From: edkcnw@comcast.net
Sent: Wednesday, March 24, 2021 12:51 PM
To: Tabitha Boschetti
Cc: Lindsey Hagerman; Steve Koper
Subject: RE: Public Comments- Notice ANN 20-0004- 23500 SW Boones Ferry Rd.

We appreciate the opportunity to provide Citizen Comments regarding the proposed ANN 20-0004 - Annexation of 23500 SW Boones Ferry Road by CPAH into the City of Tualatin.

LEA Comments
On the Draft Tualatin Stormwater Master Plan
(Dated April 2019)

**TOM RE PROPERTY
ON EAST SIDE SW BOONES FERRY ROAD NOW OWNED BY CPAH**

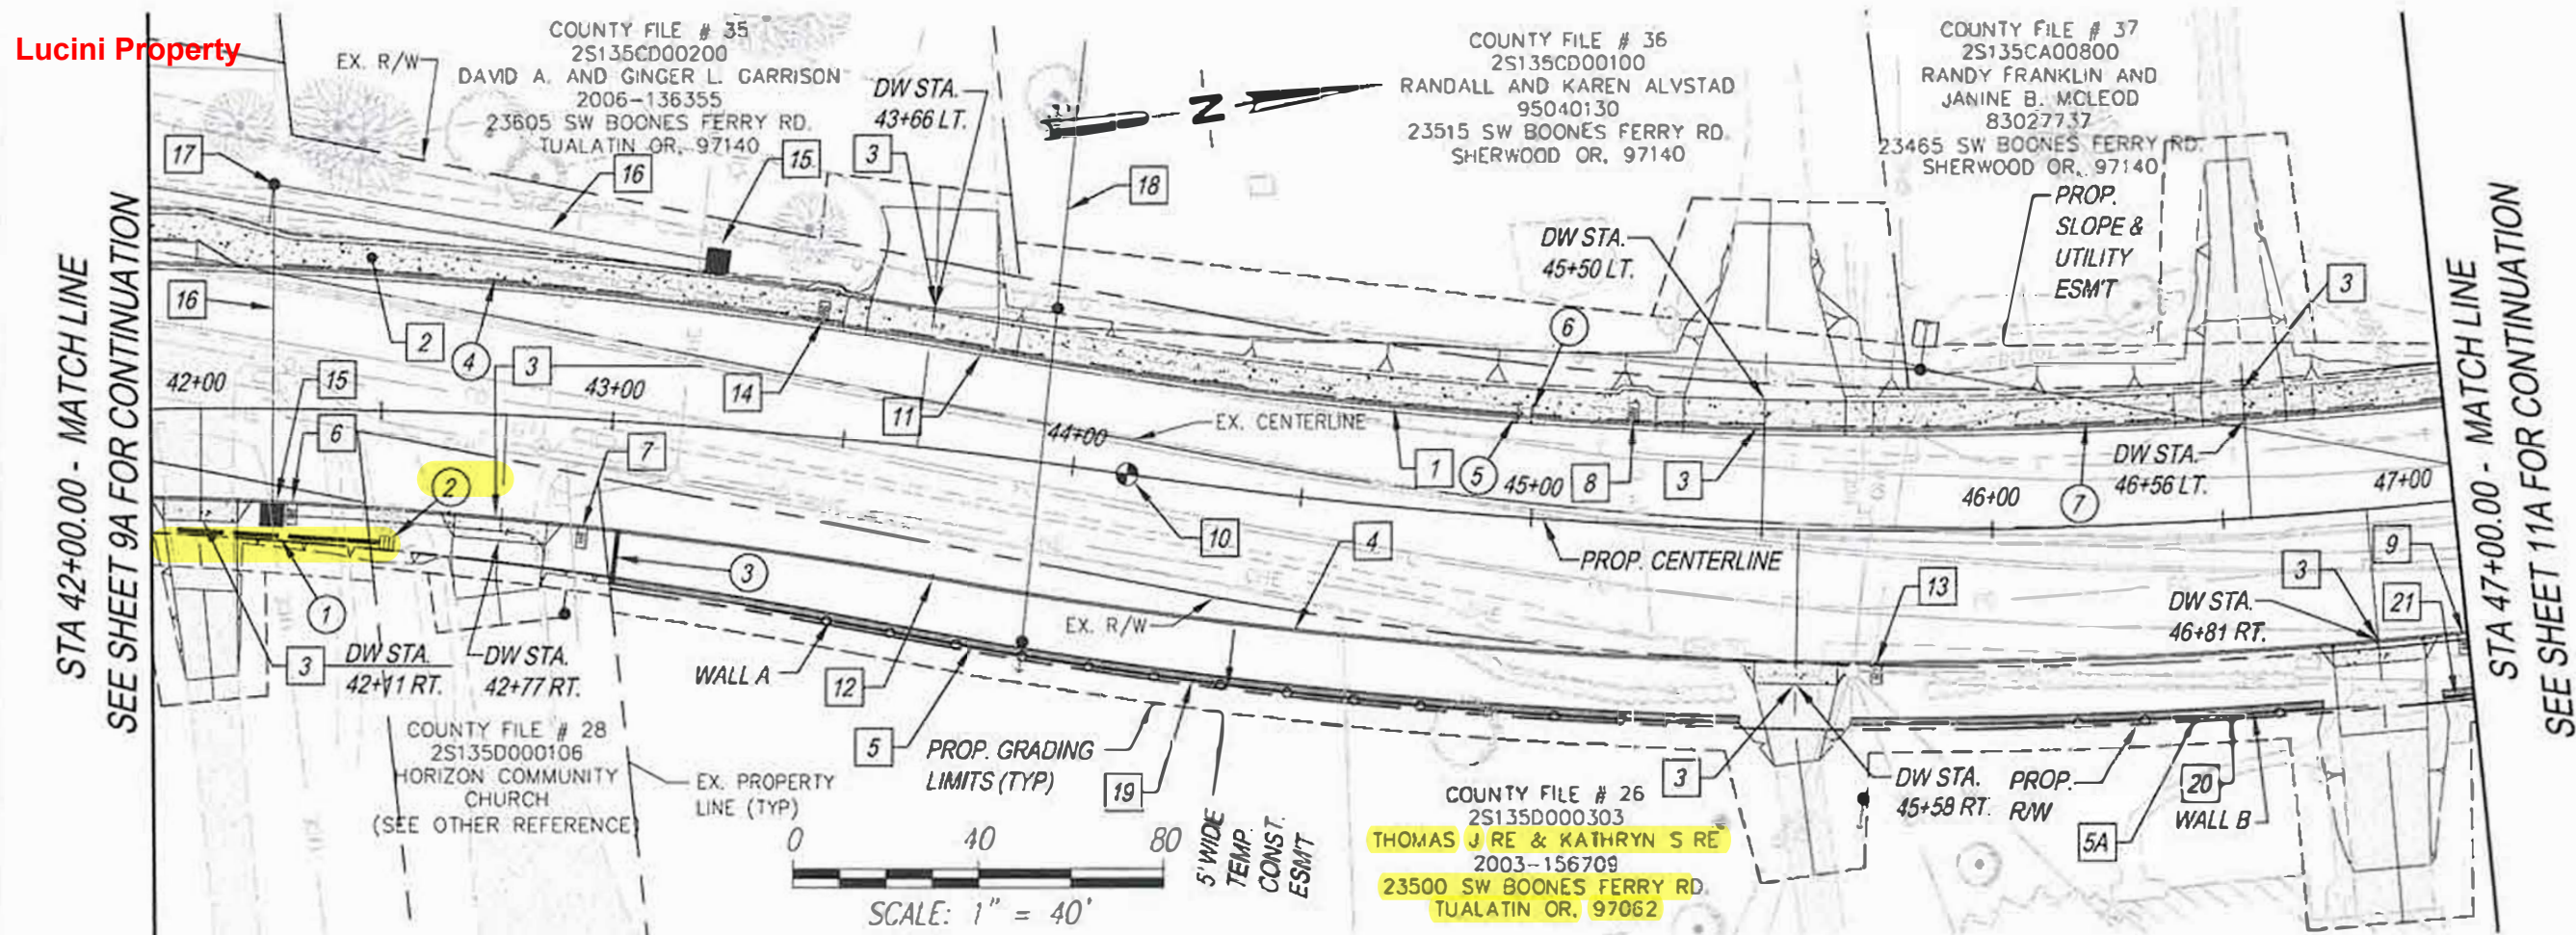
NO STORMWATER INTAKES CONSTRUCTED ON TOM RE PROPERTY

**TOPOGRAPHY OF SOUTHERN PORTION OF TOM RE PROPERTY
CAUSES STORMWATER RUNOFF TO DRAIN IN SOUTH WESTERNLY DIRECTION
INTO EXISTING CATCHMENT AREA**

**2 STORMWATER INTAKES ON EAST SIDE OF SW BOONES FERRY ROAD
FOR STORMWATER CATCHMENT (INCLUDING PORTIONS OF CPAH PROPERTY)
ARE LOCATED IN RIGHT OF WAY ON EAST SIDE OF CURB
ADJACENT TO AUTUMN SUNRISE LANDS AND/OR HORIZON COMMUNITY CHURCH DRIVEWAY**

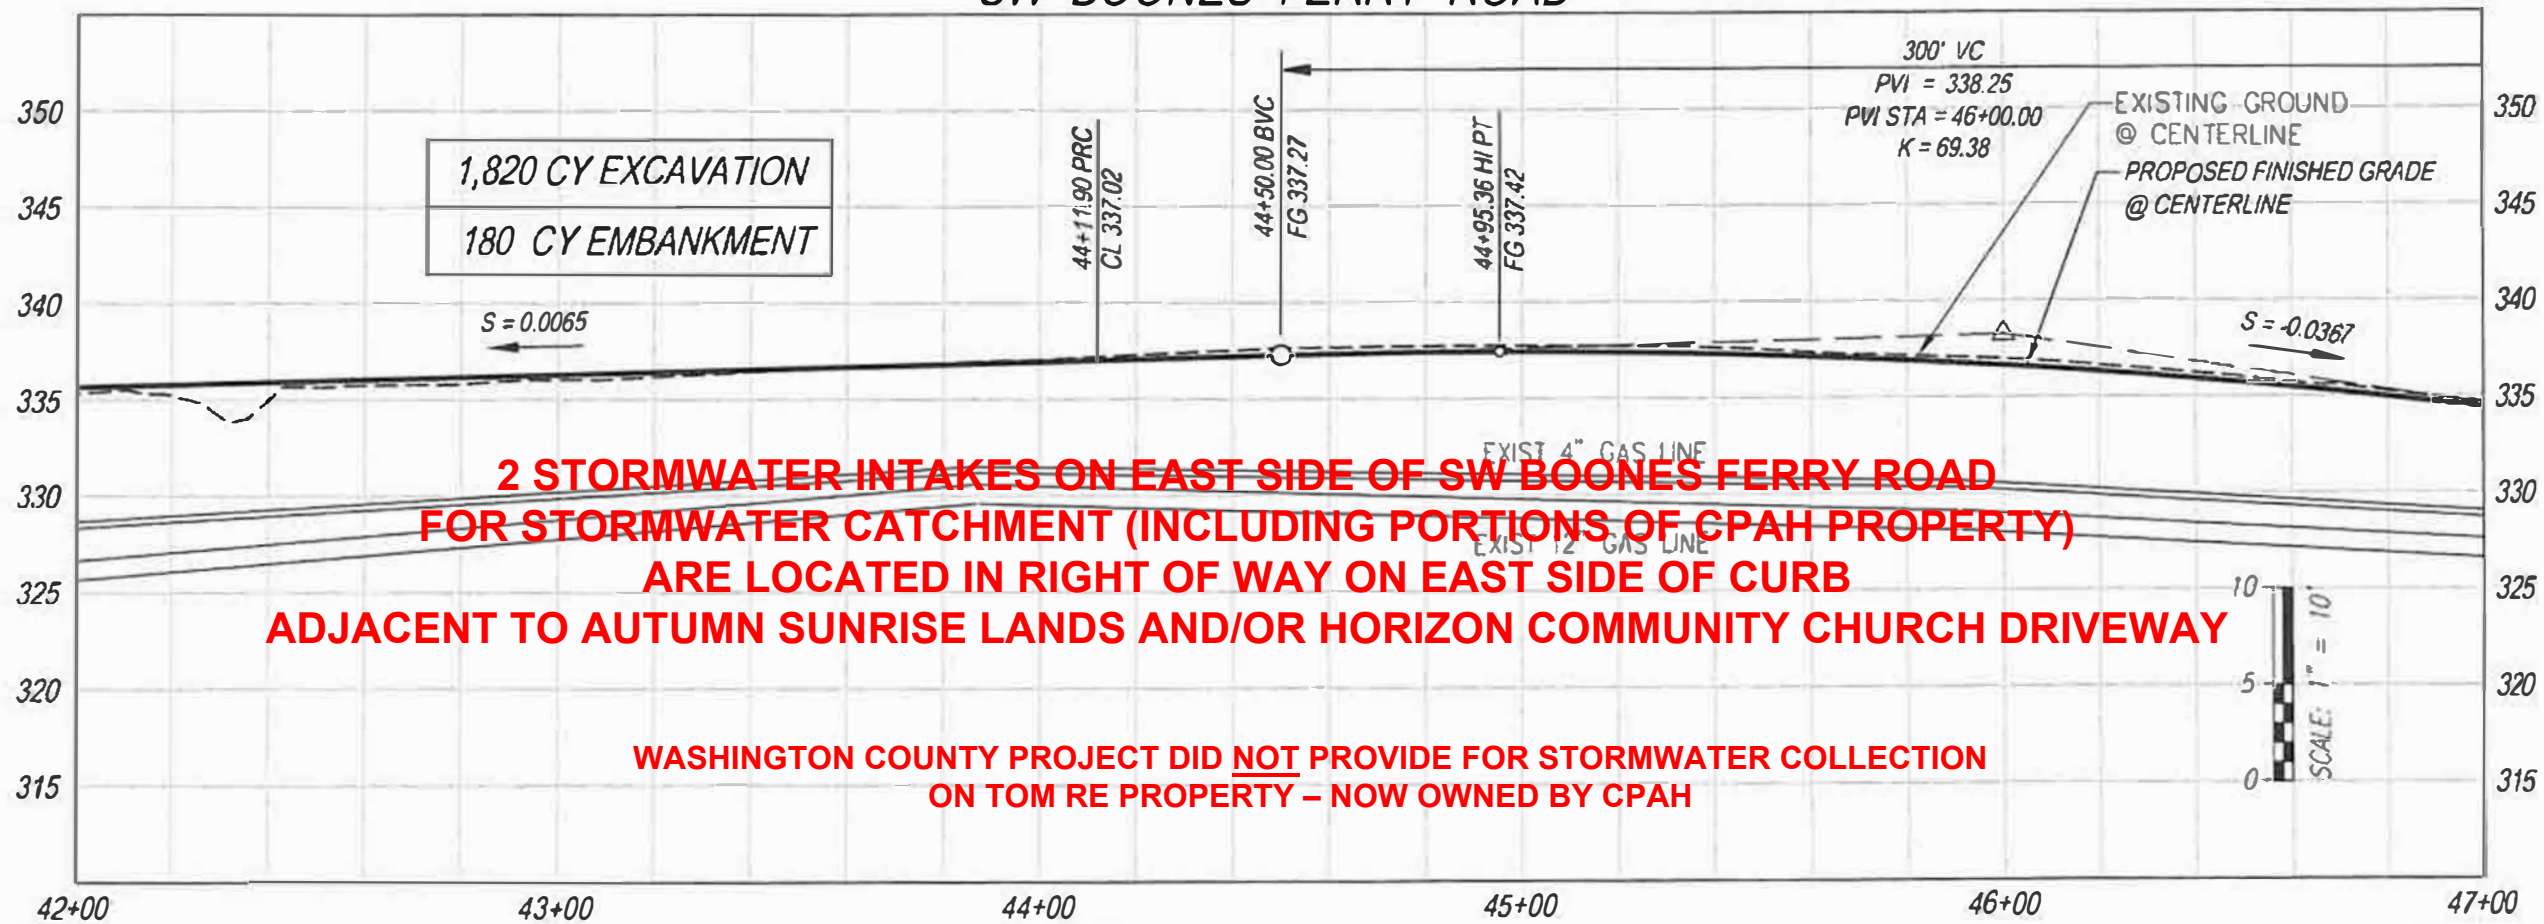
**WASHINGTON COUNTY PROJECT DID NOT PROVIDE FOR STORMWATER COLLECTION
ON TOM RE PROPERTY - NOW OWNED BY CPAH**

Figure 2-4 "Land Use" Map Not Consistent with City's Current Land Use Zoning

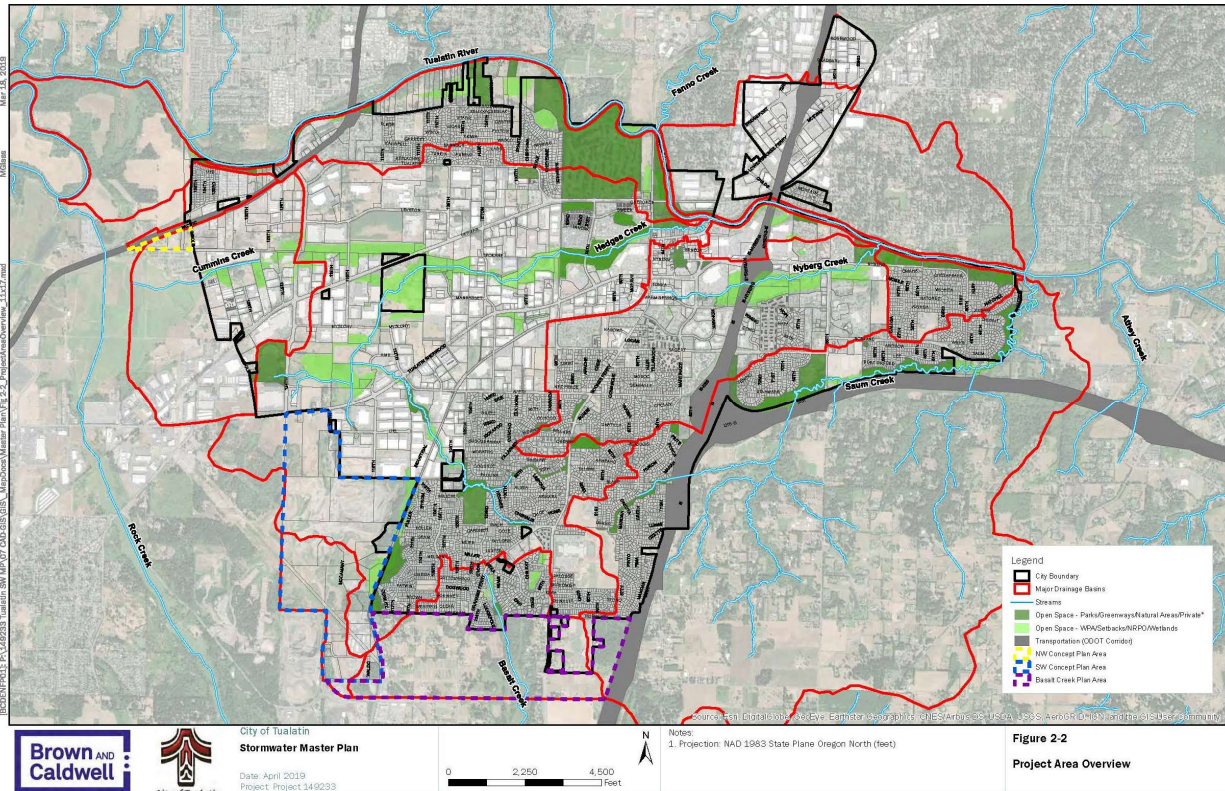
also provides the notation of "Brown and Caldwell City of Tualatin Stormwater Master Plan Date: April 2019 Project 149233 in the lower left corner of the map.

Major changes have occurred as to Land Use within the City of Tualatin in the four years since this map was apparently generated.

Figure 4. Original County Subbasins - Erroneous Boundaries for Drainage above the Lucini Property.

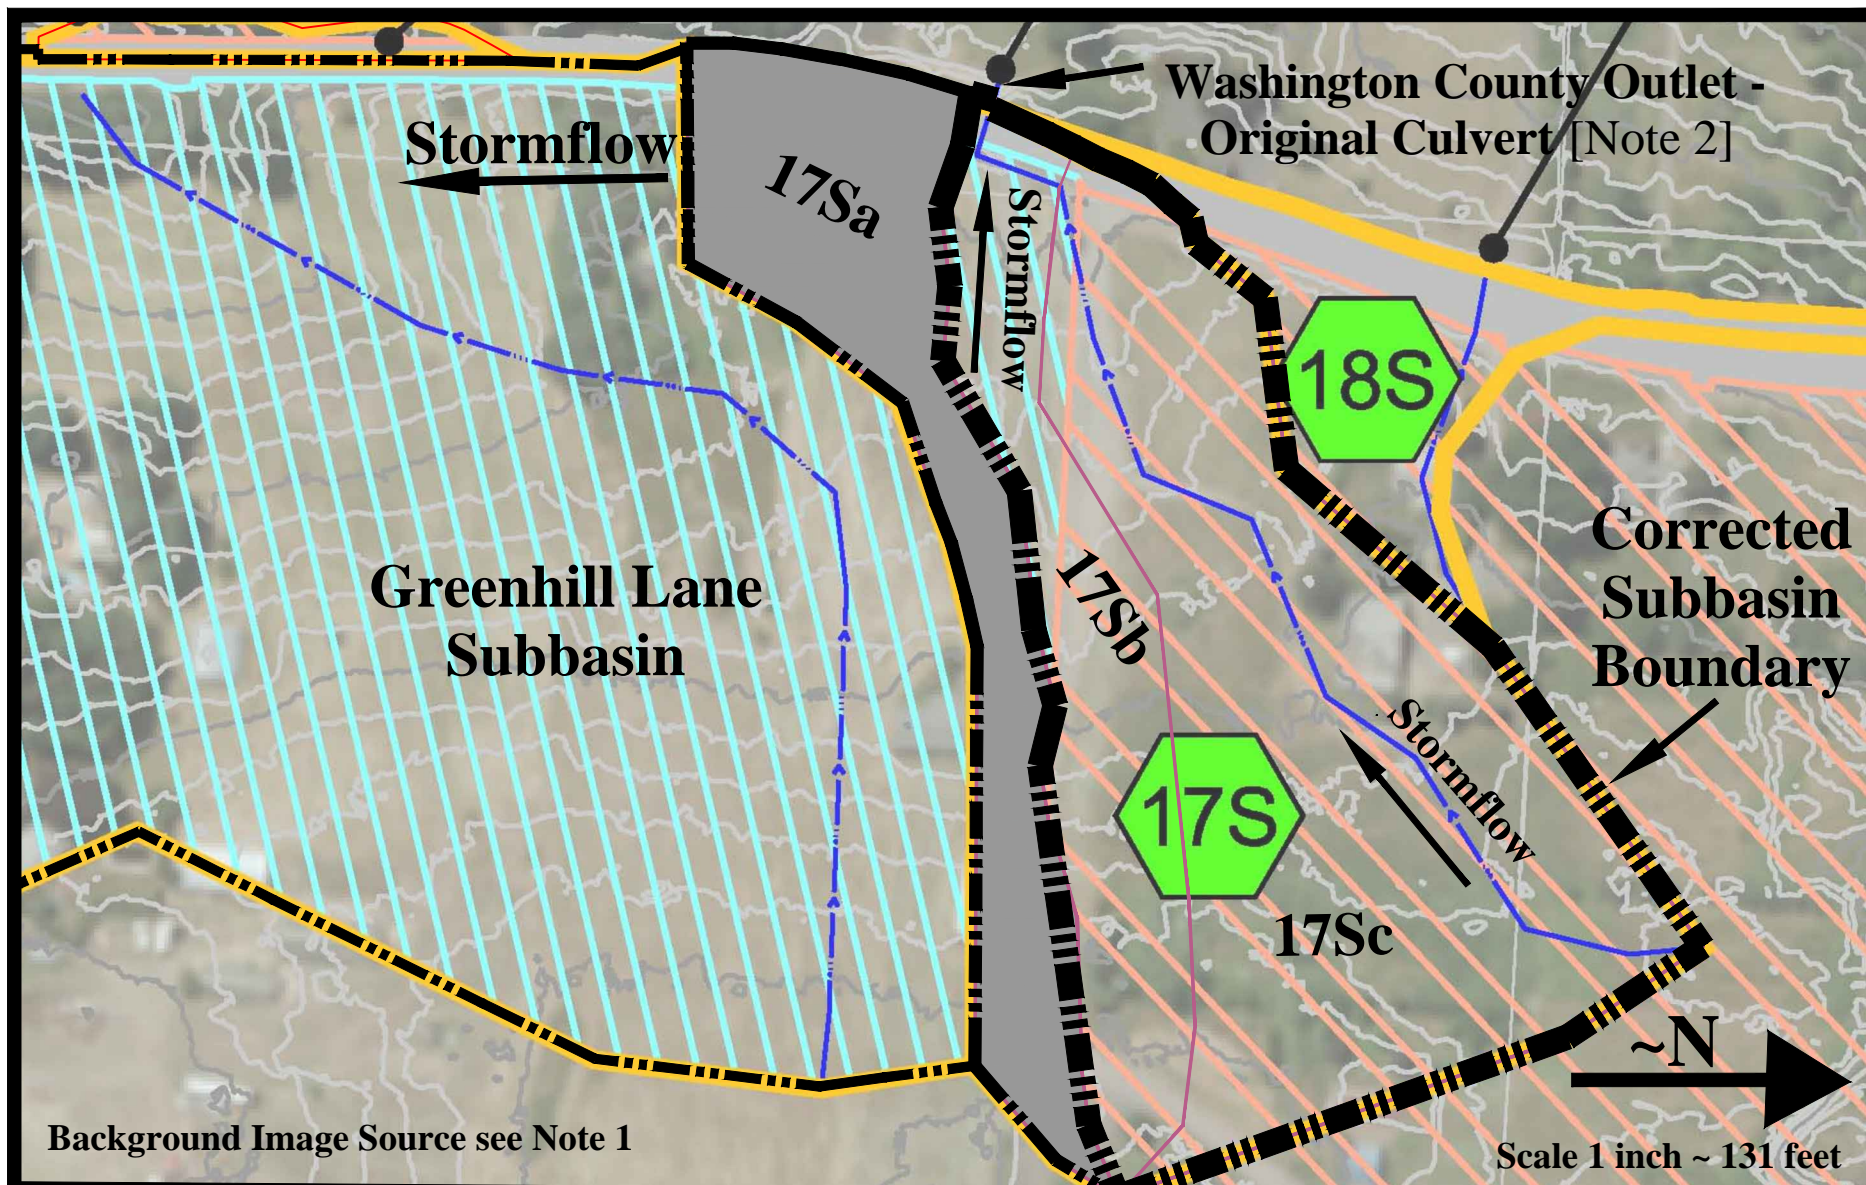
The hydrologic modeling considered a number of probable realistic cases unexamined in the Drainage Report for the 25-year design storm. The ORIGINAL subbasin configuration as depicted in Figure 4, which is corrected as shown in Figure 5. The hydrologic model was then run with the more accurate drainage area as the ORIGINAL subbasin configuration. This comparison demonstrates that the realistic (actual) peak flow value of 0.89 cubic-feet-second (cfs) discharging to the Lucini property is 31.5 percent less (see the Figure 6 column chart) than peak flow of 1.17 cfs claimed in the County's Drainage Report. This is critically important because the County is inflating the ORIGINAL stormflows and makes it seem like the ORIGINAL condition had higher flows. This is an adverse condition for the Lucini's because the Drainage Report analysis later claims to reduce the ORIGINAL stormflow amount that it previously inflated as part of the IMPLEMENTED project.

This resulted in erroneously concluding that the Boones Ferry Road right-of-way to the south of the original culvert¹³ flowed into the Lucini property. The actual Original subbasin excluded all of the rainfall runoff from the southern strip of the County’s wrongly depicted subbasin. This condition is illustrated in Figure 5, which more accurately shows the ORIGINAL stormflow from the southern strip as being routed to the Greenhill Lane subbasin.¹⁴

Figure 9. IMPLEMENTED County Subbasins - Erroneous Boundaries for Drainage above the Lucini Property.

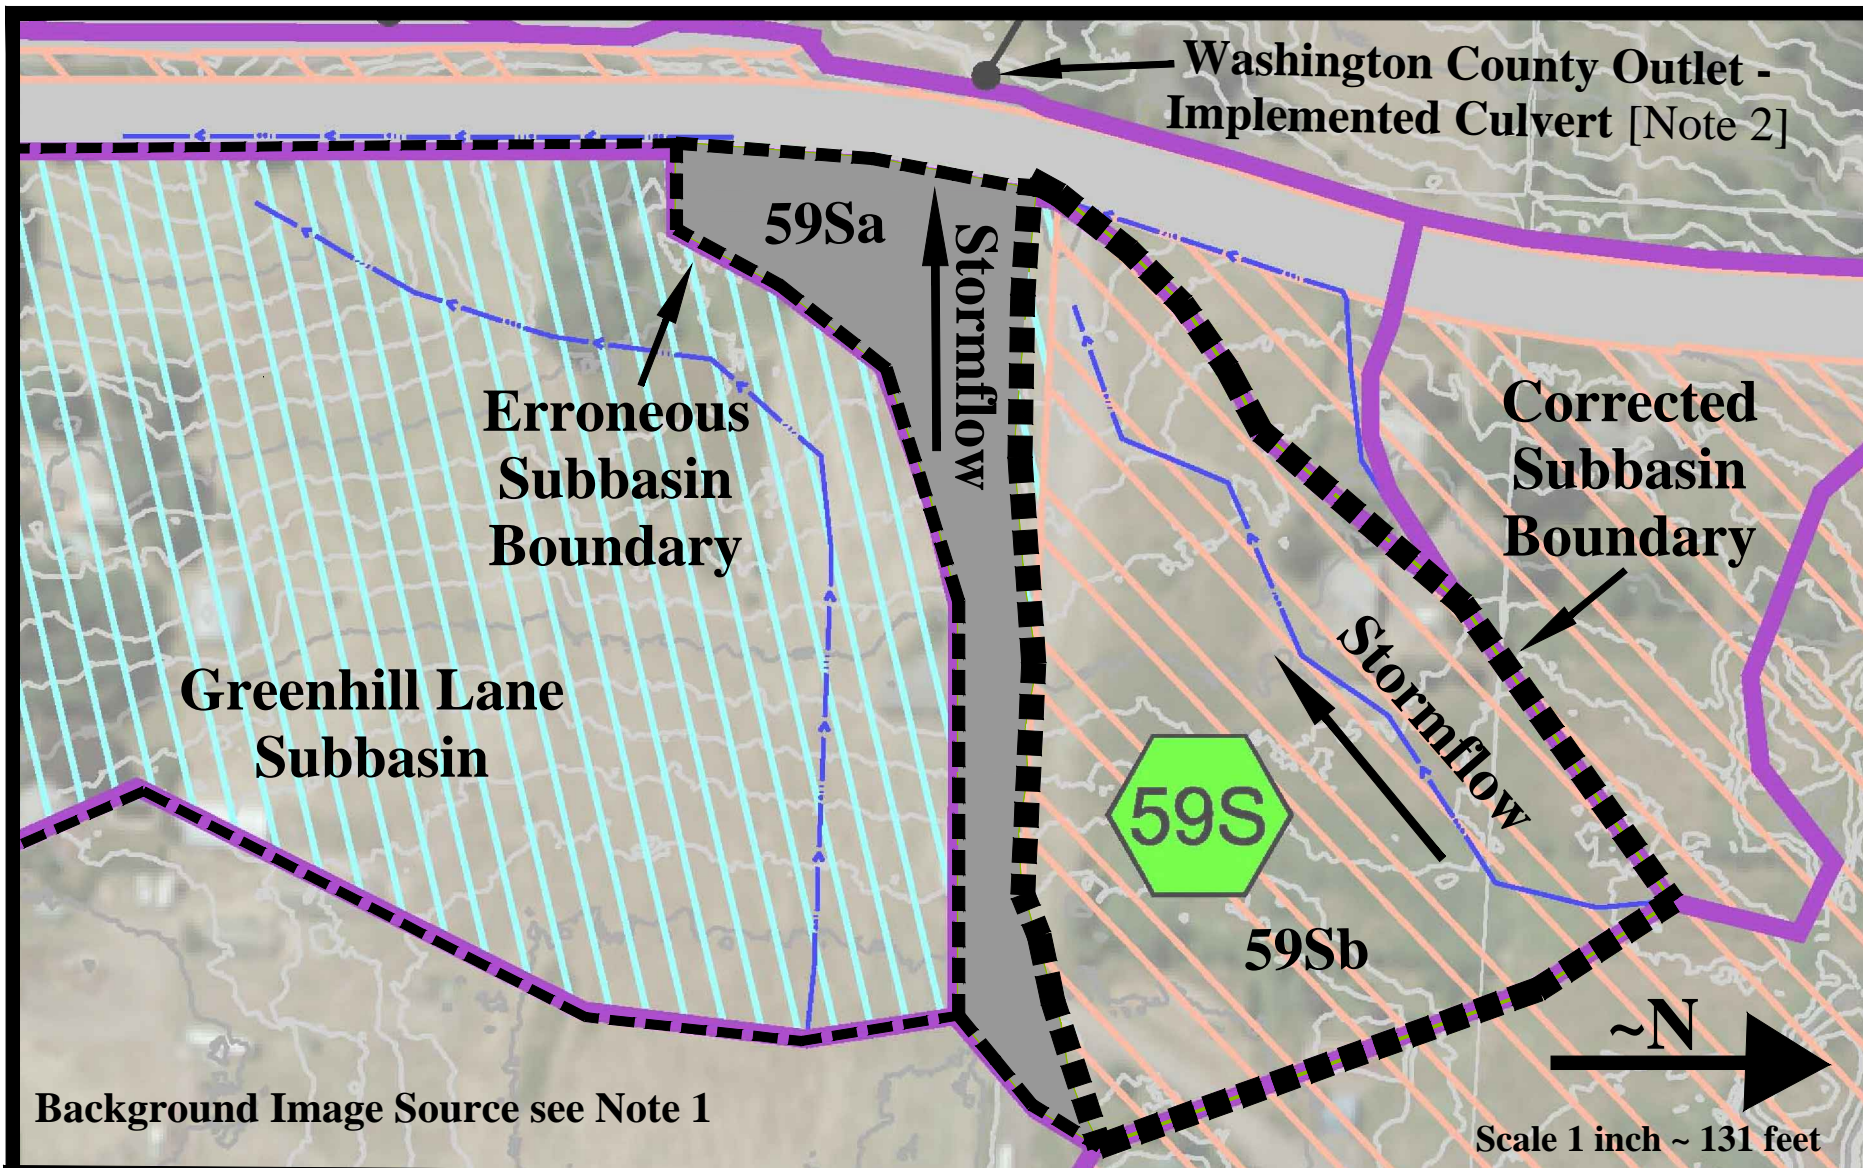
Stormflow values are graphically compared in the Figure 6 through Figure 8 column charts. Figures 9 and 10 show the subbasin boundaries for IMPLEMENTED conditions, which permanently re-rout stormflows from a portion of the Greenhill Lane subbasin ultimately onto the Lucini property

Defective County Topography and Inaccurate Original Curb and Storm Sewer Claims
Stormflows originally directed south into the Greenhill Lane subbasin, through the road right-of-way, were re-routed by the road improvement project onto the Lucini property via the County's Storm Outfall #5. As shown in Figures 4 and 5, the subbasin drainage drawings for the ORIGINAL conditions¹⁹ do not show the actual topography affecting drainage conditions. The IMPLEMENTED drainage basin conditions then re-route increased storm flows to the Lucini property.²⁰
